Service-Information Motorcycle

34 021 90
(2395)

Rear Drum Brake Shoes - All Models from 1981 on, except R80G/S

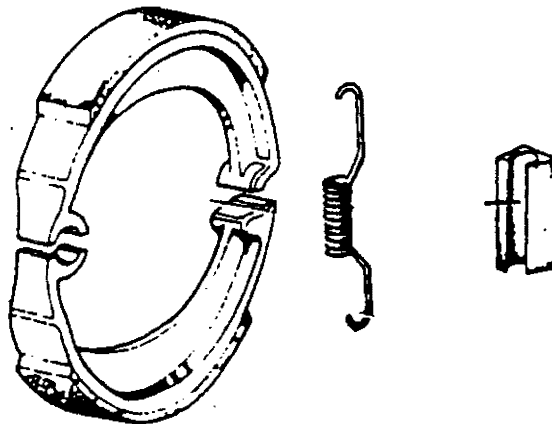
A new part number for asbestos-free brake shoes has been introduced for all rear drum brake models from model year 1981 and onward, with the exception of the R80 G/S (1981 - 1986).

This part number is a kit containing upper and lower brake shoes, 2 brake return springs, and a rubber absorber which can now be installed on the rear return spring in order to reduce the vibration of the spring which causes the squealing noise during braking.

Part Number 34 21 2 310 523
